Access Compliance Report

Public Rights-of-Way

(Curb Ramps)

Intersection ID: 44266	Main Street: ISAAC_HUNTER_DR	Cross Street: ASHLYN_ELIZABETH_CT	Location: NE
ADA ID: 8F2450C1E545	Ramp Type: Perpendicular Diagonal	Initial Pass/Fail: Fail	Overall Compliance: No
		Severity Score: 57.5

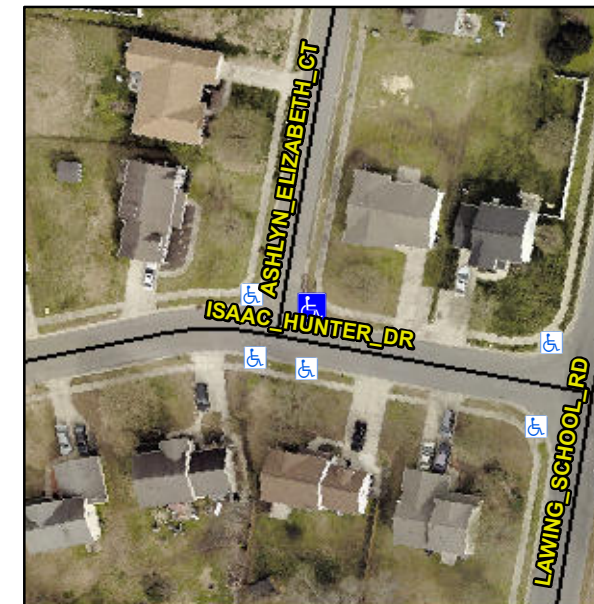
Not Found, R304.5.1, R304.2.2, R304.5.3, R302.7

Compliance	Description	Data	Compliance	Description	Data
N/A	Ramp Length (in)	48.5	No	Ramp Slope (%)	11.3
No	Ramp Width (in)	33.0	No	Ramp XSlope (%)	5.1
N/A	Flare Type LT	N/A	N/A	Flare Type RT	N/A
N/A	Flare Slope LT (%)	N/A	N/A	Flare Slope RT (%)	N/A
N/A	Flare Traversable LT?	N/A	N/A	Flare Traversable RT?	N/A
N/A	Landing Length (in)	N/A	N/A	DWS Provided?	N/A
N/A	Landing Width (in)	N/A	N/A	DWS Contrast?	N/A
N/A	Landing Slope (%)	N/A	N/A	DWS Length (in)	N/A
N/A	Landing X Slope (%)	N/A	N/A	DWS Full Width?	N/A
N/A	Landing Curb? (Y/N)	N/A	N/A	DWS Offset (in)	N/A
N/A	Shared Landing?	N/A			
N/A	Gutter Ponding?	N/A	N/A	Gutter Slope (%)	N/A
N/A	Gutter Lip Ht (in)	N/A	N/A	Gutter X Slope (%)	N/A
N/A	Painted X Walk1?	No	N/A	Painted X Walk2?	No
	X Walk 1 Direction	To W		X Walk 2 Direction	To S
N/A	X Walk 1 Width (in)	N/A	N/A	X Walk 2 Width (in)	N/A
	X Walk 1 Slope (%)	3.8		X Walk 2 Slope (%)	4.8
	X Walk 1 X Slope (%)	4.3		X Walk 2 X Slope (%)	5.9

Remove & Replace Curb Ramp With Two New Directional Ramps or Equivalent.
